STAFF REPORT  
October 1, 2024  
Site Plan Review of Parcel Id # 05-917-00-07-005.00

Application for a Site Plan Approval

Application to approve a site plan for the Fairview Townhomes project located within the Fairview Crossing development's Conceptual Overlay Plan. The application includes 16 4-unit townhomes (64 total units) on Lot 1 of the subdivision.

LANDSCAPE PLAN  
SCALE: 1" = 30'

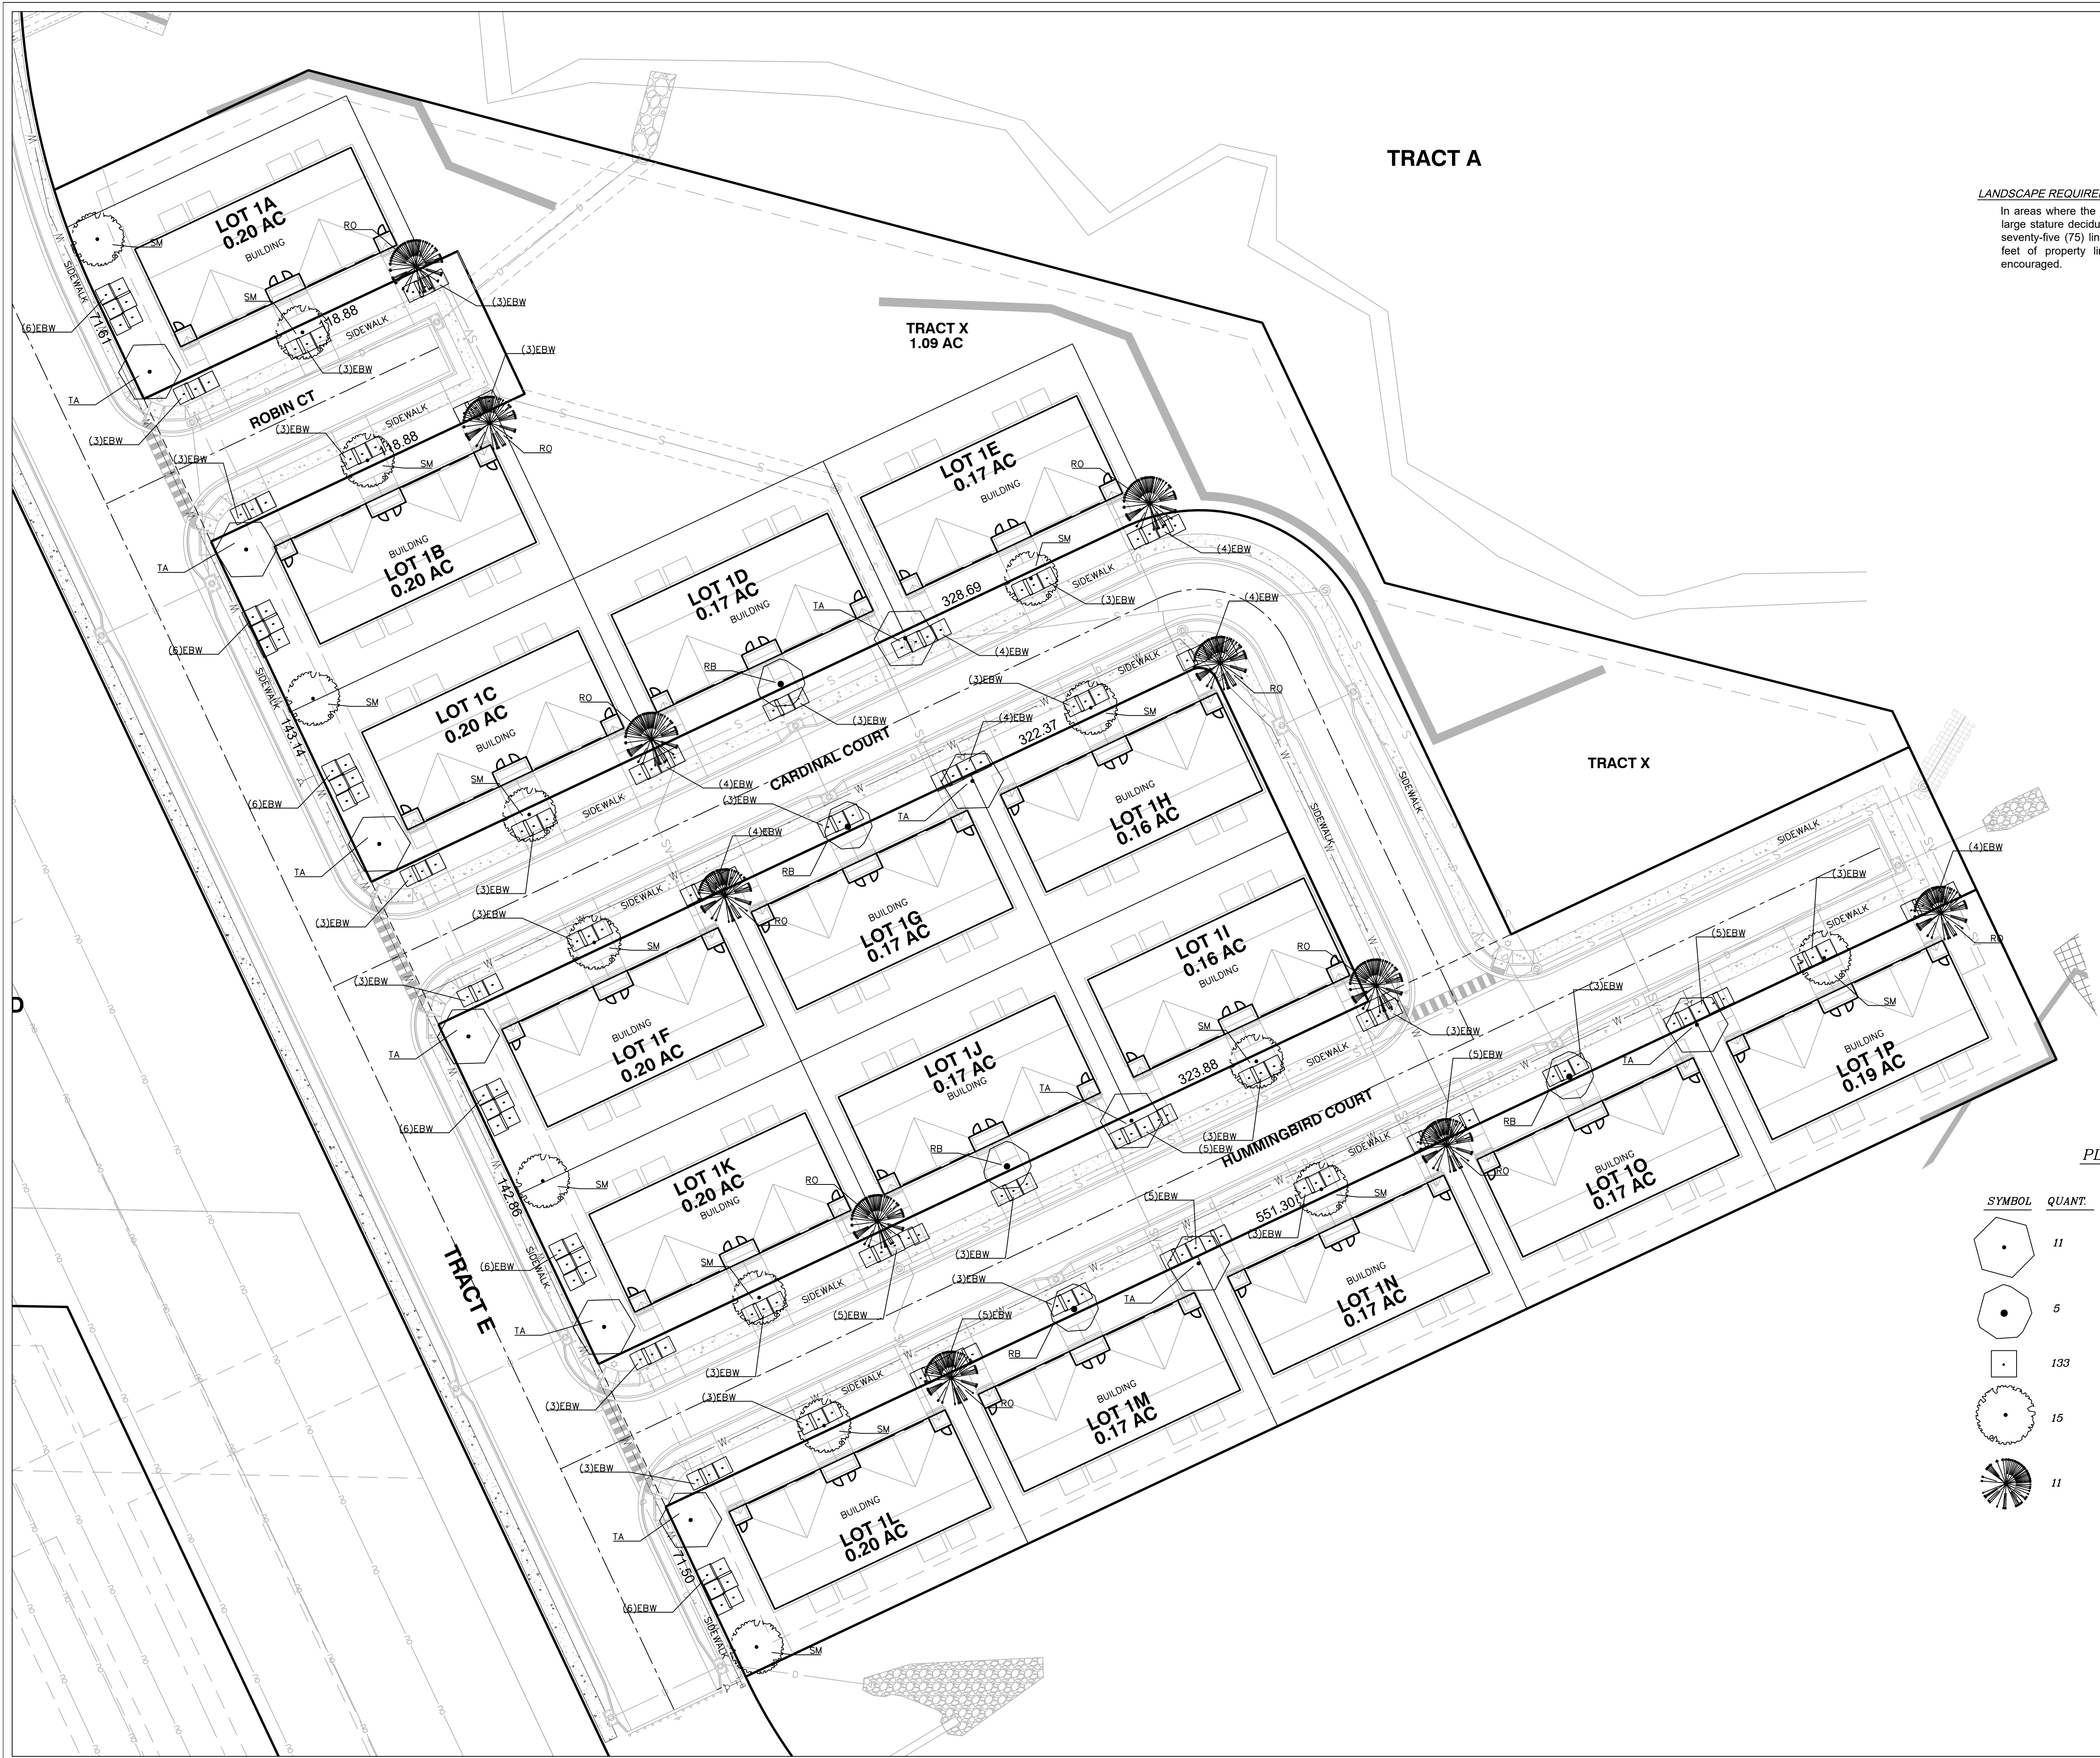
6. Landscaping Standards. To maintain the general residential feel of the development, landscaping should be designed in accordance with its location. In all developments, existing mature trees that are not required to be removed for construction should remain in place. The development should be buffered from adjacent roadways with either a combination of berms and medium stature trees, or without berms a combination of both higher stature trees and low standing non-deciduous trees or shrubs. Grouping or clustering such trees in a natural looking state is desired. In the event a building or parking area is adjacent to a public street, the landscape buffering requirements in Section 400.435(C)(3) shall be met. ***The submitted landscaping plan meets the standards.***
